Subject: Erratum and Addendum to the Risk Management Plan, Polvorosa Business Park, San Leandro, California

**Risk Management Plan  
Polvorosa Business Park  
1555 Doolittle Drive  
San Leandro, California**

**May 6, 1998  
1204.00-004**

POLVOROSA BUSINESS PARK  
**Groundwater Elevation Contours**  
 May 26, 1995

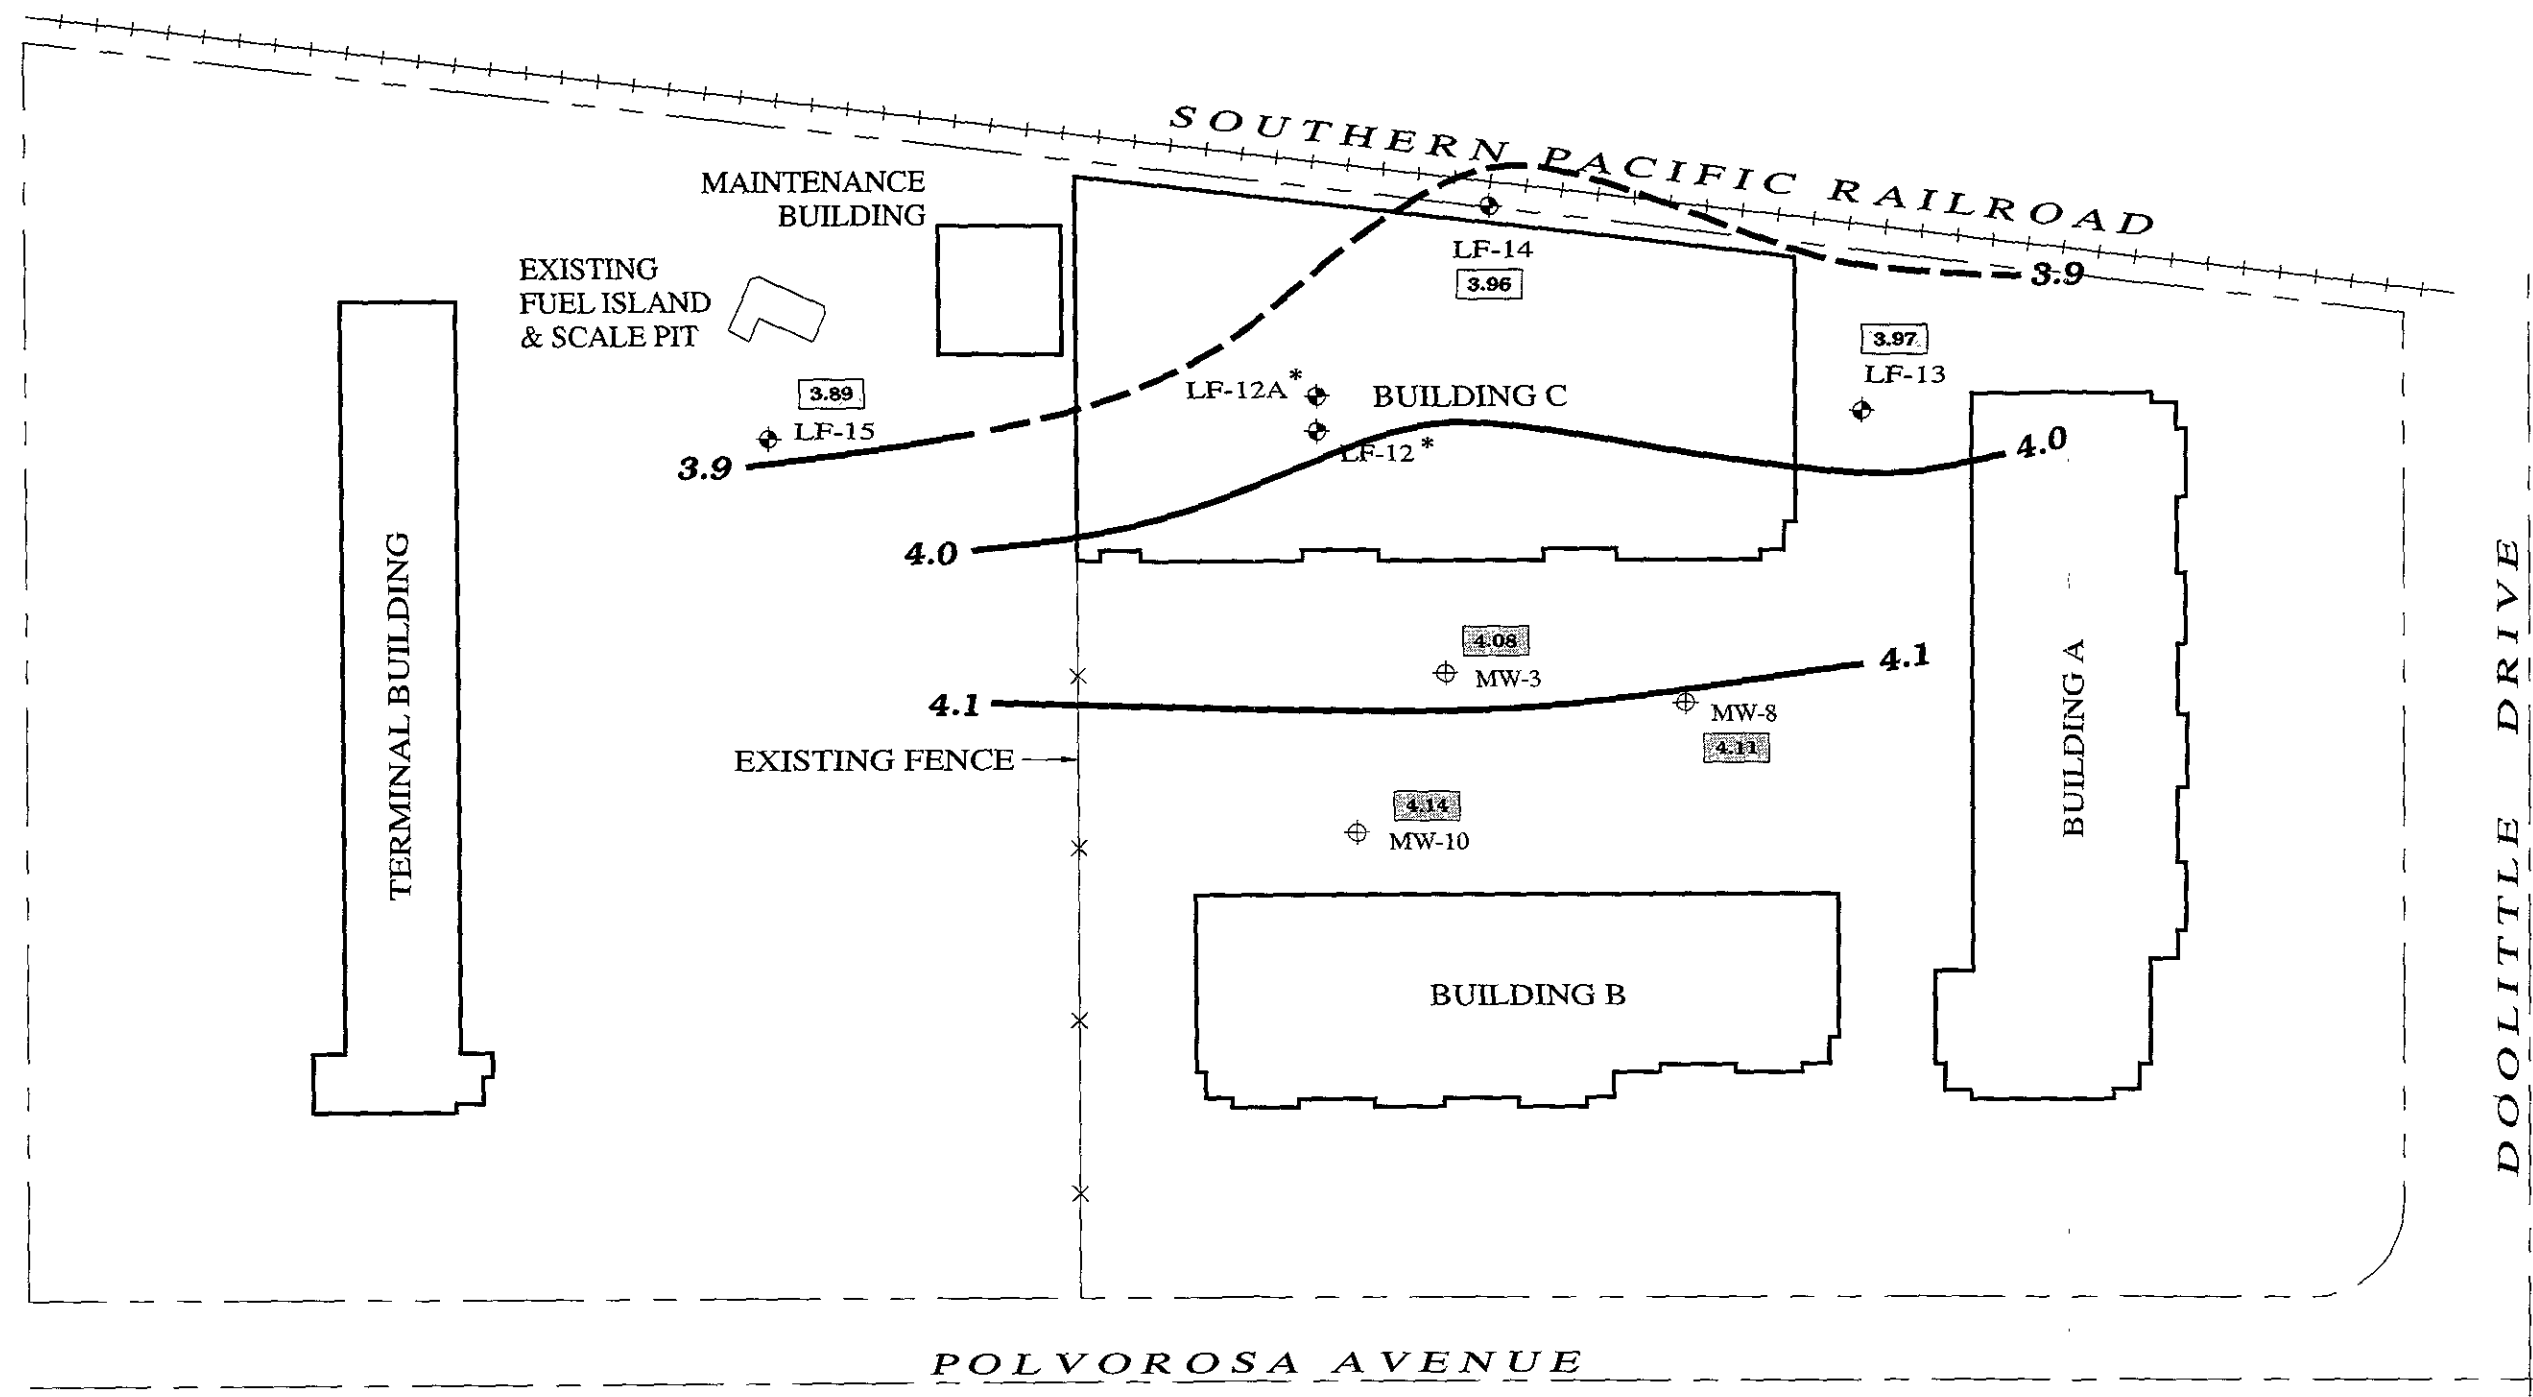
LFR reviewed a site grading plan and utility plans showing the locations and depths of underground storm drains, sanitary sewers, and water lines. These plans indicate that the depth of

these utilities does not exceed 5 feet bgs in the vicinity of Building C at the Site (Figure 1). Because the historical depth to groundwater at the Site has been greater than 6 feet bgs, underground utilities do not provide a preferential pathway for petroleum hydrocarbons in groundwater to migrate away from the Site.

**Petroleum Hydrocarbon Concentrations  
in Groundwater (ppm), May 26, 1995**

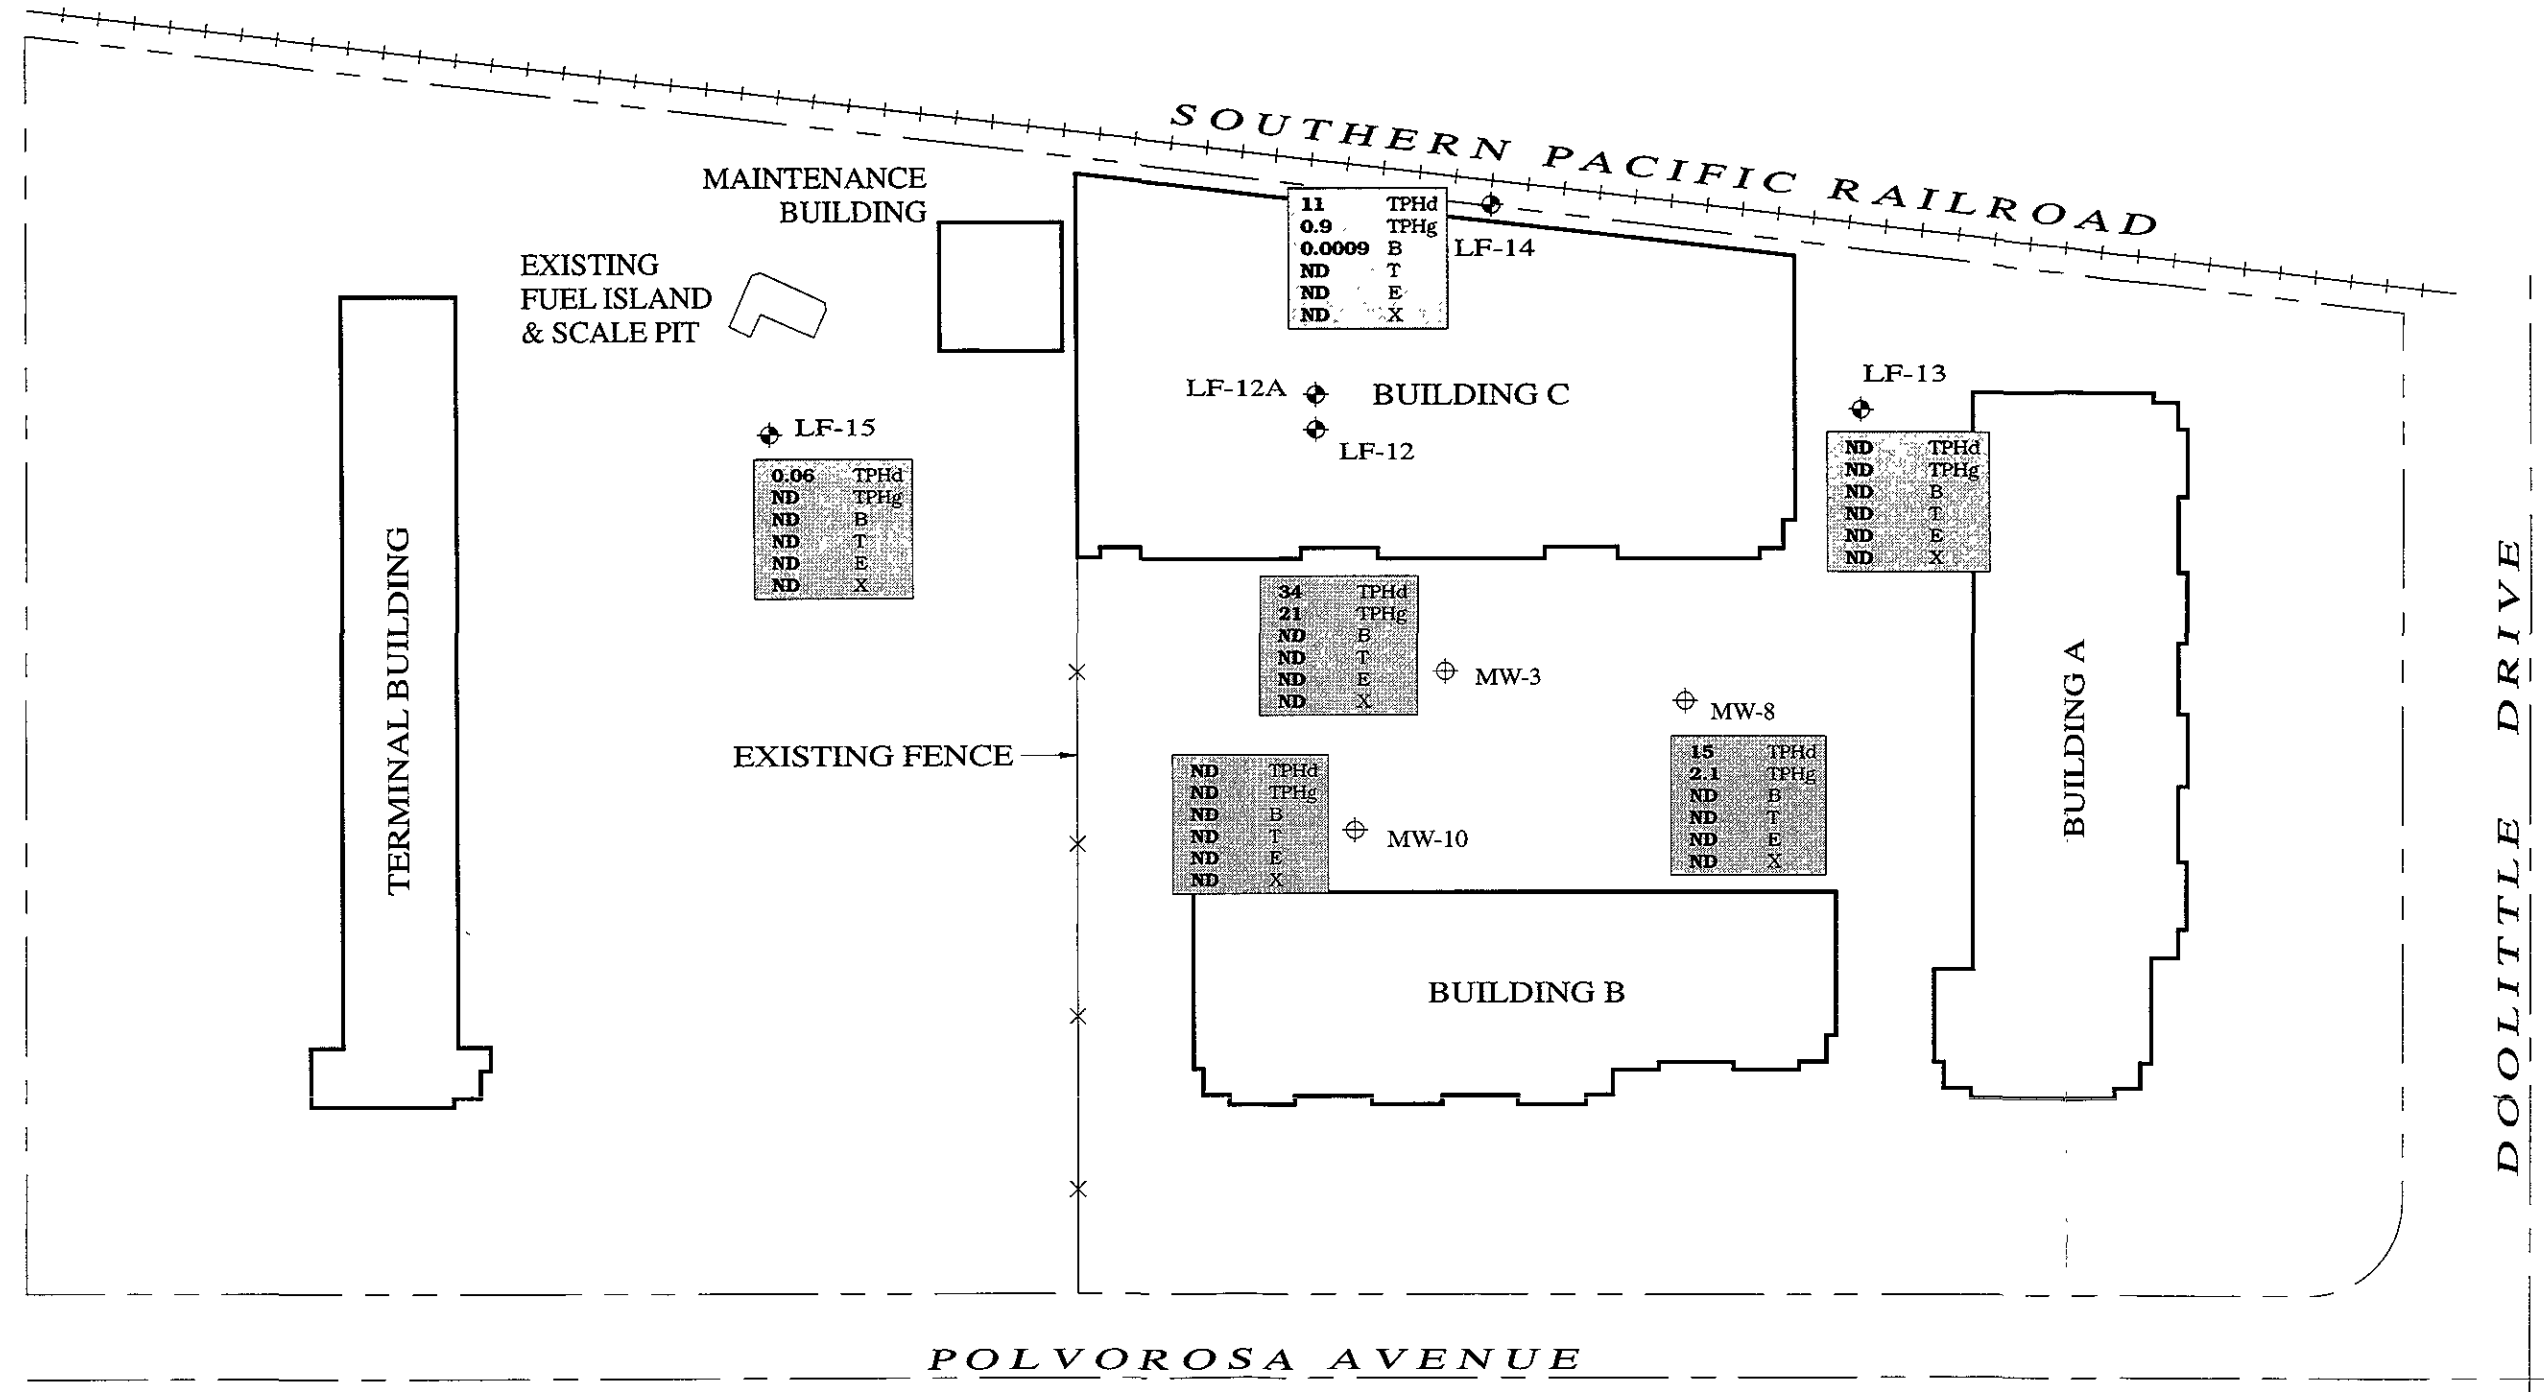
Groundwater quality data collected during four quarterly monitoring events, conducted from September 1994 through May 1995, are summarized in Section 2.2.3 of the RMP. Figure 2 shows groundwater quality analysis results for May 26, 1995, the most recent date on which groundwater samples were collected at the Site. As shown in Figure 2, the highest concentration of TPHd in May 1995 was detected in monitoring well MW-3 (34 ppm), and lower concentrations of TPHd were detected in wells MW-8 (15 ppm) and LF-14 (11 ppm) on this date. A low concentration of benzene (0.0009 ppm) was detected in downgradient well LF-14 on this date.
